Application No.	Applicant(s)	•
Notice of Allowability	10/765,074	SCORER, MICHAEL	
	Examiner	Art Unit	
	Benny Lee	2817	
The MAILING DATE of this communication appear All claims being allowable, PROSECUTION ON THE MERITS IS herewith (or previously mailed), a Notice of Allowance (PTOL-85) NOTICE OF ALLOWABILITY IS NOT A GRANT OF PATENT RIOF of the Office or upon petition by the applicant. See 37 CFR 1.313	(OR REMAINS) CLOSED in this app or other appropriate communication GHTS. This application is subject to	olication. If not included will be mailed in due course.

EXAMINER'S AMENDMENT

Fig.8.

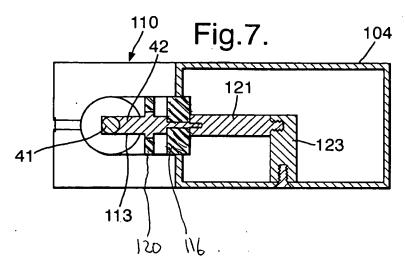
material, in a manner similar to that depicted by Fig. 2; In Figs. 7, 8, the dielectric beads (116,

120) should be cross-hatched as a dielectric material, in a manner similar to that depicted by Fig.

2; In Fig. 7, reference labels --116-- & --120-- and corresponding leads lines therefore should be
